# 118 Congress Street

## Bike Racks

1. **Proposed Amendment to an Approved Plan:** On Wednesday, March, 18<sup>th</sup>, David Lloyd, representing Chip Newell, applicant, requested an amendment to the approved site plan to install a custom made bike rack in the public right-of-way parallel to the curb line. As part of the submission, Chip Newell has offered to have the condominium maintain and replace the bike rack (e-mail attached).

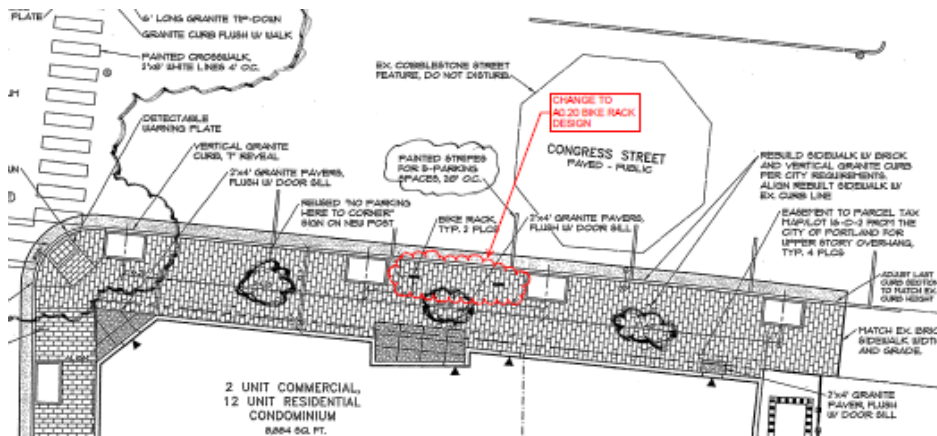
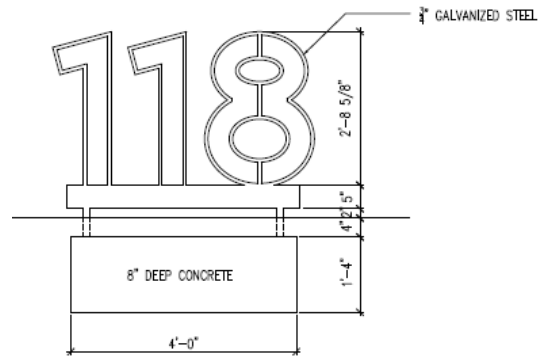
2. **Approved Plan: and Technical Manual Standards:** The custom rack was submitted in the original submission, but the final approved plans show two Dero bike racks meeting the City's standards located in the public sidewalk (shown above). Since the plan showed the required type of bike racks in the public right-of-way, this was not raised as an issue. An excerpt from the Transportation Section of the Technical Manual is as follows:

If it's on private property, we can approve it if I get more details on materials on placement, etc.

If it's in the public ROW we will not likely approve it (unless it was explicitly ALREADY part of the signed off/approved site plan). It would need to be a Bike Hitch or the Downtown Rack. We turned down a similar custom bike rack at the Press Hotel within the public ROW.

At the DPS meeting and the Development Review meeting, Tom Errico questioned the functionality of this bike rack. The longterm maintenance was also raised along with support for a unified municipal streetscape for such features, so it is clear the rack is for public use. Also, as designed it is hard to distinguish this as a bike rack versus signage for the building.

6. **Staff Recommendation:** The staff continues to recommend that the custom made bike rack be located on the private property and to retain the two Dero bike racks in the public right-of-way.

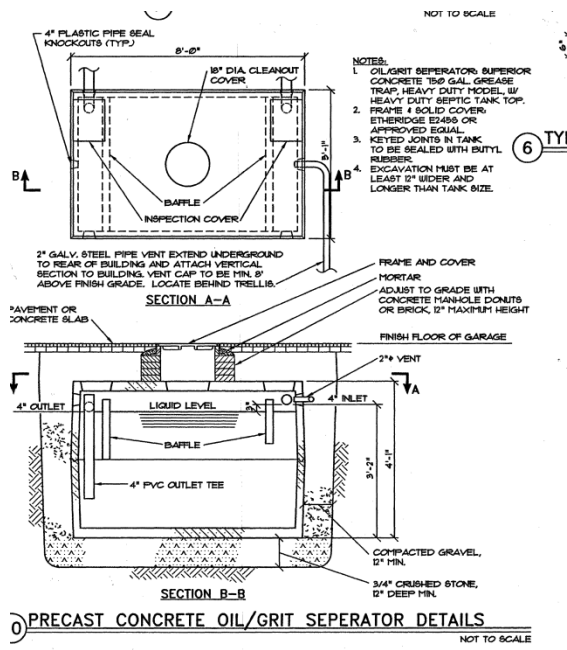
Bike Racks: Deb Andrews, Caitlin Cameron, Bruce Hyman and I have looked at the proposed bike racks. While the design is attractive, Deb articulated well the urban design goals for the public infrastructure. The technical manual calls for the Dero bike hitch and we concur that the city standard should be used in this location. Bruce did ask to see the actual dimensions on the site plan for distance between the curb line (need a minimum of 24"). A minimum of 8" is needed for separation from raised granite planters, but I assume you will proceed with the flush grates.

While the design of the proposed bike rack was attractive and related to the Hotel, the City needs to consider the desired continuity of neighborhood streetscape features. Consistent treatment of sidewalks, tree wells, and other features are intended to knit individual buildings into the larger public streetscape. In addition, the City becomes responsible for the maintenance and replacement of public infrastructure located within the street right-of-way. Thus Portland's Technical Manual specifies the

requirements for infrastructure to be installed in the city right-of-way, including the standards for the bike racks. <http://me-portland.civicplus.com/DocumentCenter/Home/View/2353> Refer to pages 65 and 66 in the Transportation section for bike racks.

The technical manual has specifications for street lights that are chosen to reflect the character of specific neighborhoods. The city is open to considering alternative bike racks that meet functional requirements, quality of materials/finish, cost effective to maintain, and relate to the neighborhood context. This would require amendments to the Technical Manual that must be adopted by the Planning Board. Bruce Hyman, Transportation Program Manager, is aware of your interest and others to consider alternatives. Currently, the position for the bike and pedestrian coordinator is vacant, but it is something that could be considered at a later time.
